STAFF REPORT
COMMUNITY DEVELOPMENT DEPARTMENT

SUBJECT: H-2022-0039
Slatestone Subdivision

Request for Annexation and Zoning of 5.04 acres of land with the R-8 zoning district and a preliminary plat consisting of 15 single-family building lots and 4 common lots on 4.85 acres in the requested R-8 zoning district, by T-O Engineers.

PRELIMINARY PLAT FOR
SLATESTONE SUBDIVISION
A PORTION OF THE NE 1/4 OF THE NW 1/4 OF SECTION 24,
TOWNSHIP 3 NORTH, RANGE 1 WEST, BOISE MERIDIAN
ASB COUNTY, IDAHO
SEPTEMBER 21, 2022

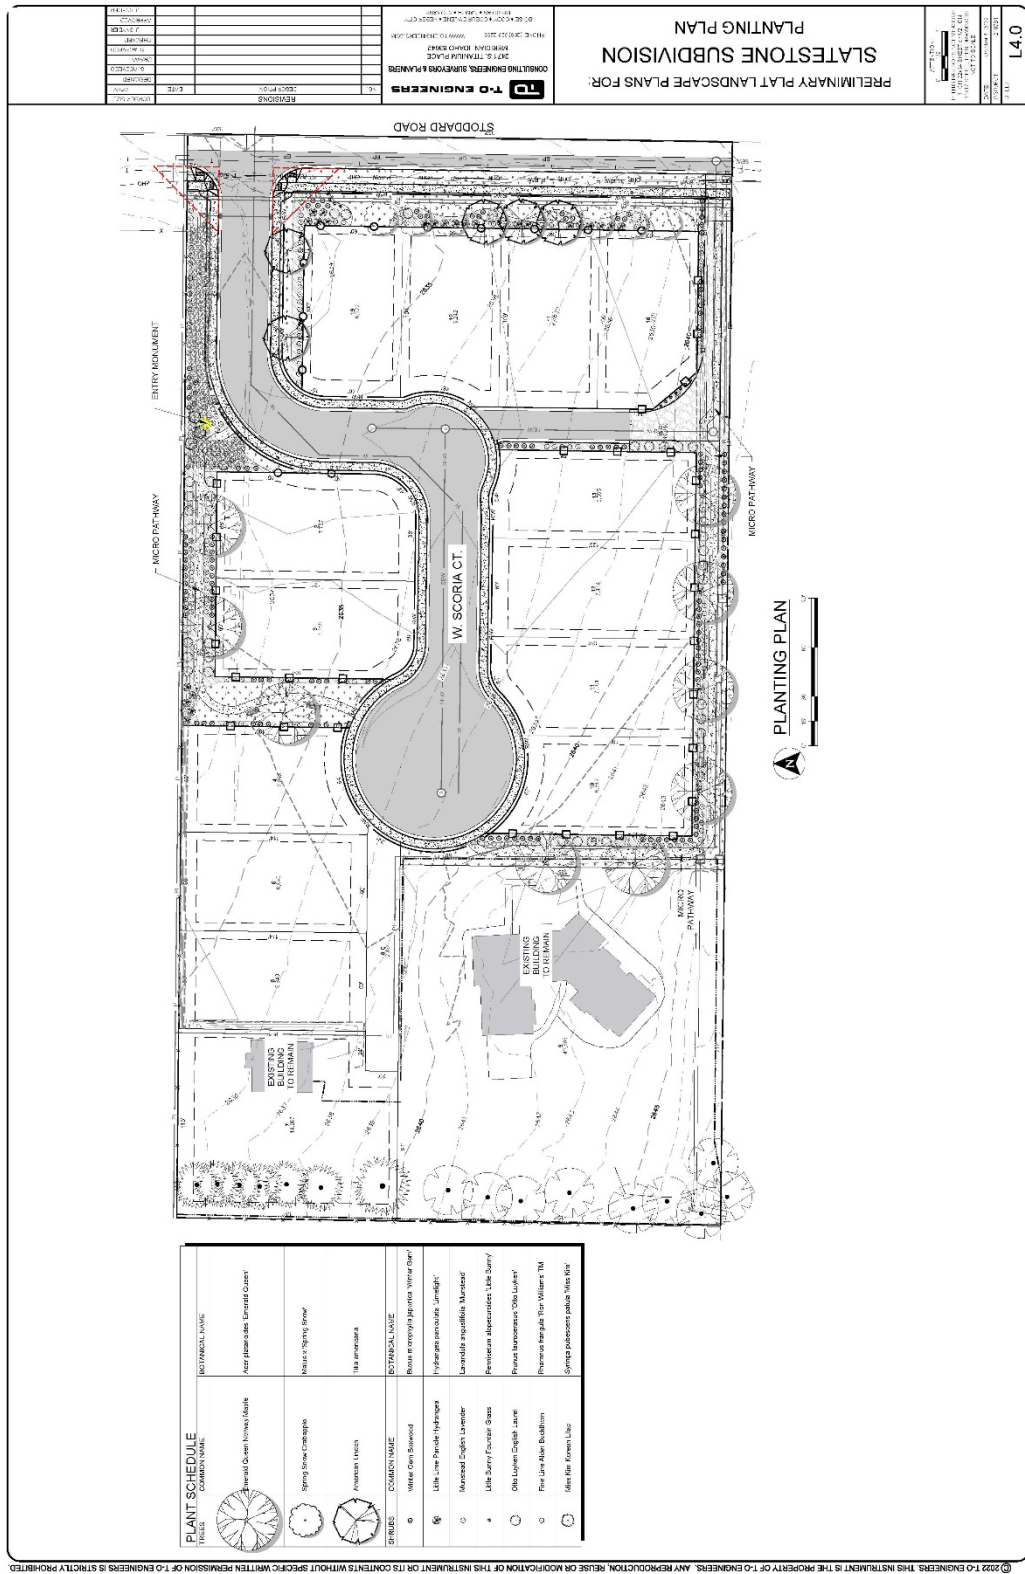
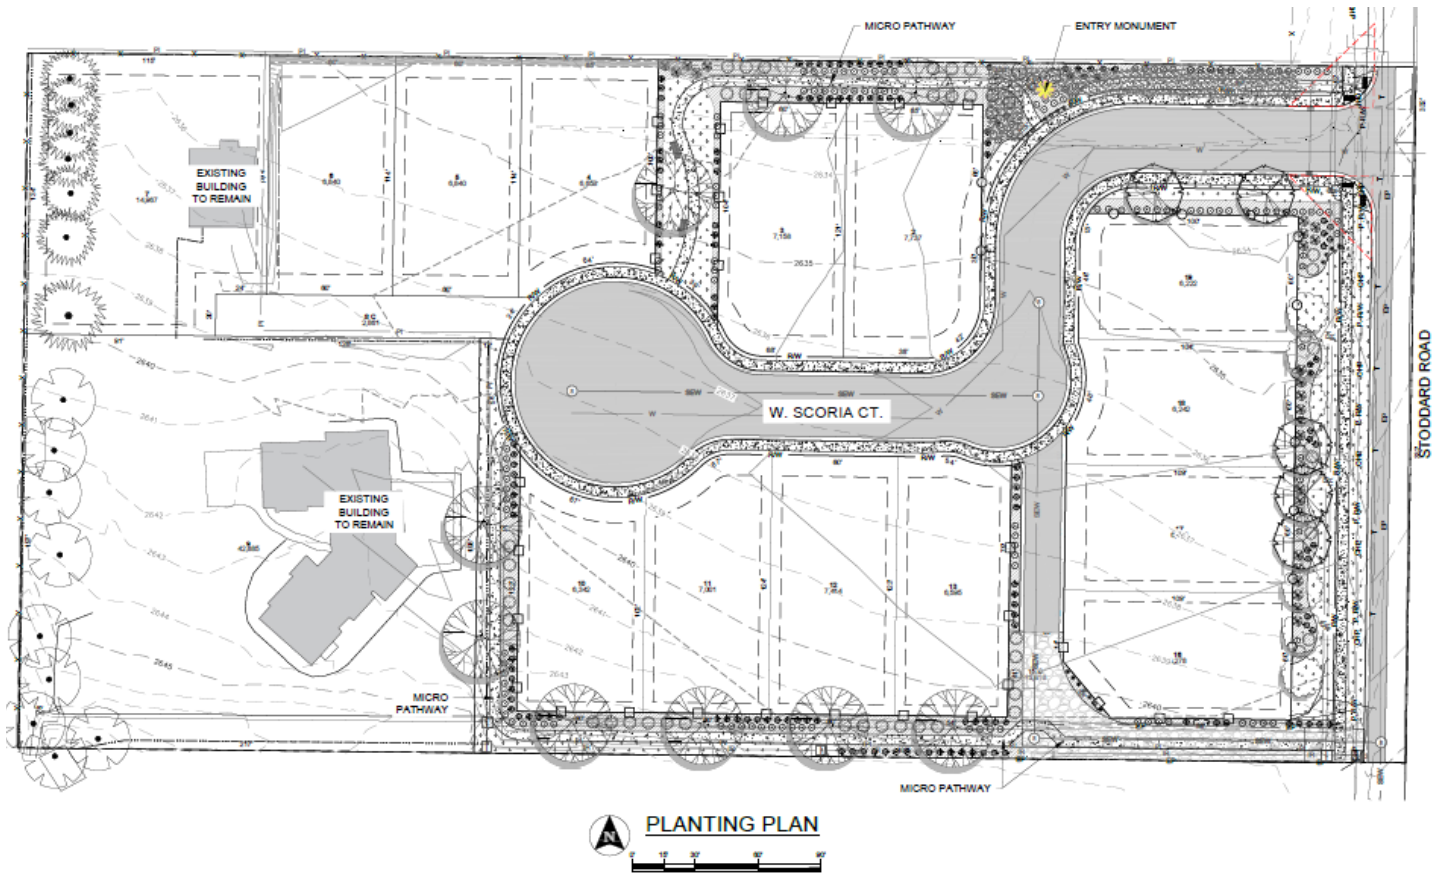
The Applicant is proposing two (2) common drives within the project; one in the southeast corner of the project for access to Lots 16 & 17 and an additional common drive near the northwest corner for access to four lots (Lots 5-7 and Lot 9). Lot 8 common drive appears to comply with all standards outlined in UDC 11-6C-3D. However, the construction of the Lot 14 common drive does not appear to comply as it creates a sidewalk gap on the public street and does not extend 20 feet past the property line for Lot 16. ACHD does not call this out in their staff report but Staff finds that Lot 14 should match Lot 8 in its design and not be a part of the public road network as depicted on the submitted plans. The Applicant should continue the curb, gutter, and 5-foot sidewalk between Lots 13 & 18 consistent with the curve of the public street and mirror the design of the Lot 8 common drive. In addition, the Applicant should extend the common drive 6 feet further to the south to ensure at least 20 feet of frontage for Lot 16. The Applicant should make these revisions with the first final plat submittal.

Staff does have concerns with the proposed micro-paths and sidewalk connection near the common drive at the southeast corner of the site, Lot 14. According to the submitted plans, the micro-path connects to the common drive and utilizes it as a pedestrian pathway. The City does not desire this type of design for pedestrian and vehicles to share the same surface if it can be avoided. Therefore, Staff is recommending 5-foot wide sidewalk be added to the common drive on either side of the common drive for added pedestrian safety. This recommendation will require the 5 feet to be taken from the adjacent lot to the west (Lot 13) or the lots to the east (lots 16-18).

Because the Applicant is placing a sewer main within a common lot, it must have a drivable surface over top for City access. This is shown on the submitted plans but also depicts a hammerhead type turnaround that is not required by the City. Because it is not required, Staff recommends removing the western piece of this turnaround to square up the southeast corner of Lot 13 and provide more area that can be landscaped behind Lot 13 up to the required 20-foot wide sewer main easement.

According to satellite imagery, the subject site contains an irrigation ditch along the southern boundary. The submitted plat depicts this irrigation ditch but does not show it on the subject property. In accord with UDC 11-3A-6B.3, if the irrigation ditch is on the subject property, the Applicant is required to pipe the ditch.

2. The preliminary plat included in Section VII.B, dated September 21, 2022, shall be revised as follows prior to submitting for Final Plat approval:
 - a. Make necessary revisions to the plat to match the revisions made to the landscape plan in Exhibit VII.C above.
 - b. Show all linear open space to be at least 20 feet wide consistent with UDC 11-3G-3 standards or lose one of the buildable lots in lieu of a larger and centralized open space lot with a commensurate amenity that is code compliant.
 - c. Direct lot access to S. Stoddard Road is prohibited in accord with UDC 11-3A-3.
 - d. Correct the plat to show curb, gutter, and 5-foot attached sidewalk between Lots 13 & 18 consistent with the curve of the public street
 - e. Show the common drive on Lot 14 to be six (6) feet further to the south to ensure at least 20 feet of frontage for Lot 16.

- g. Remove the western piece of the turnaround up to the required 20-foot wide sewer main easement shown in Lot 15 to square up the southeast corner of Lot 13 and provide more area that can be landscaped behind Lot 13.

- h. Depict the required 10-foot wide multi-use pathway along S. Stoddard Road and place it at least four (4) feet outside of the ultimate curb and gutter location to allow for landscaping on both sides of the pathway. Prior to the City Engineer's signature on the final plat for Phase 1, a 14-foot wide public pedestrian easement shall be submitted to the Planning Division and recorded for the multi-use pathway as required by the Park's Department, unless ACHD requires ones.
